TA 21

SUBJECT: SUPPLEMENTAL RESPONSE TO THE NOTICES OF DEFICIENCY FOR THE VOLUNTARY CORRECTIVE ACTION COMPLETION REPORT ADDENDUM FOR SOLID WASTE MANAGEMENT UNIT 21-013(d)-99

**Supplemental Response to the Notices of Deficiency
for the Voluntary Corrective Action Completion Report Addendum
for Solid Waste Management Unit 21-013(d)-99**

Figure 5. Comparison between 2003 and 2004 chromium, copper, and nickel concentrations in tuff samples

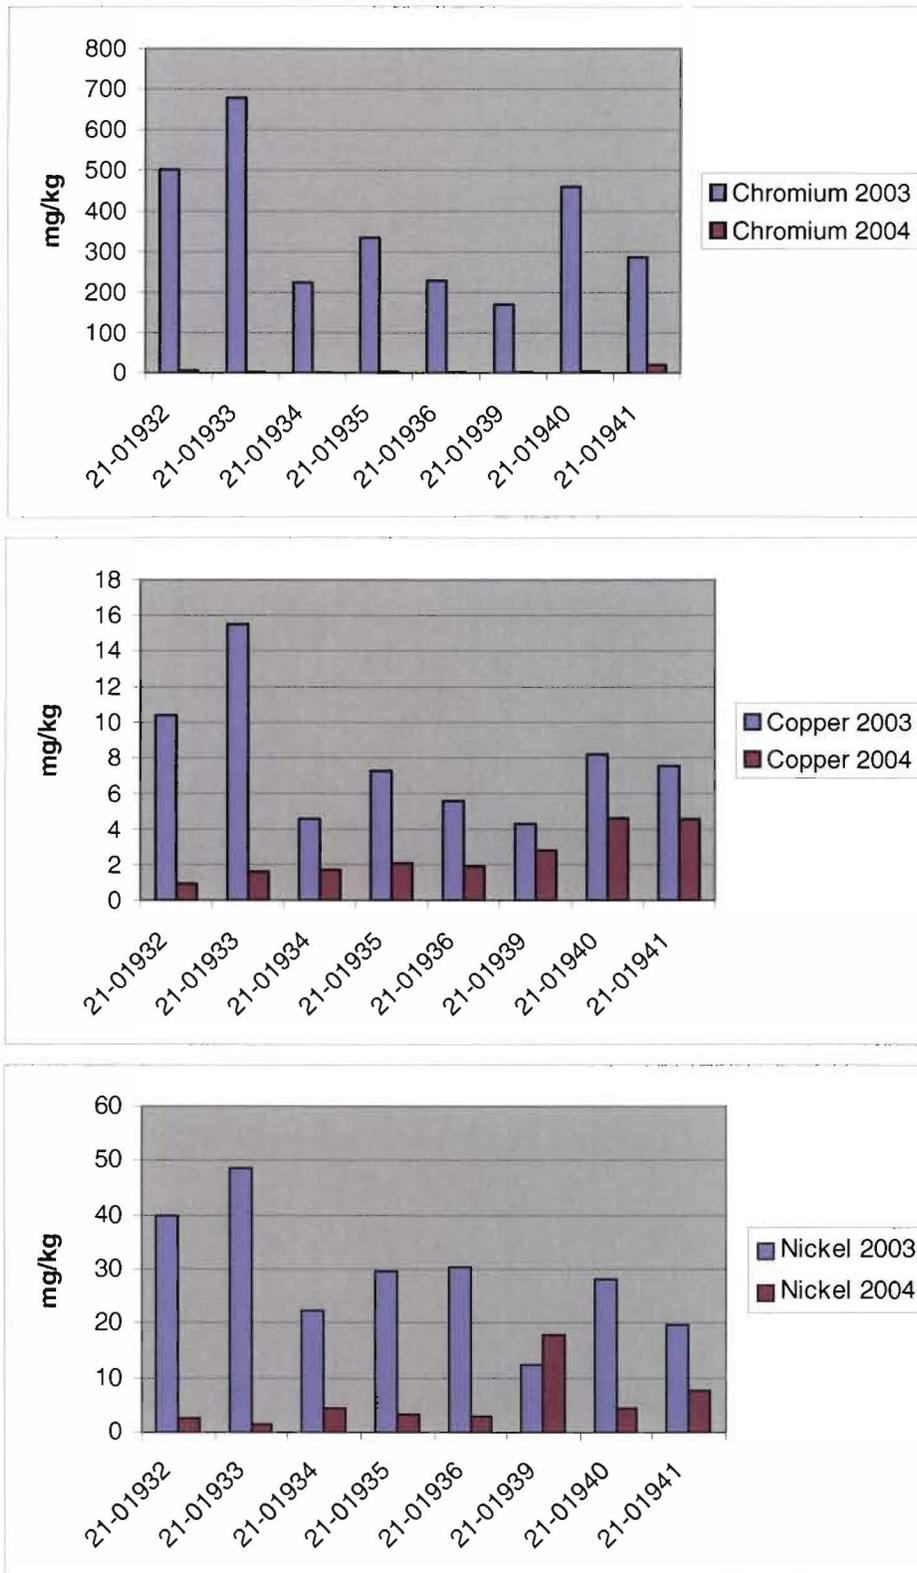
In Tables 1 and 2, the results exceeding BVs are shaded. Graphs comparing the 2003 and 2004 concentrations of chromium, copper, and nickel are shown in Figure 5. Note that no results from either 2003 or 2004 exceed the residential soil screening levels (SSLs) (NMED 2004, 85615; EPA 2003, 81724).
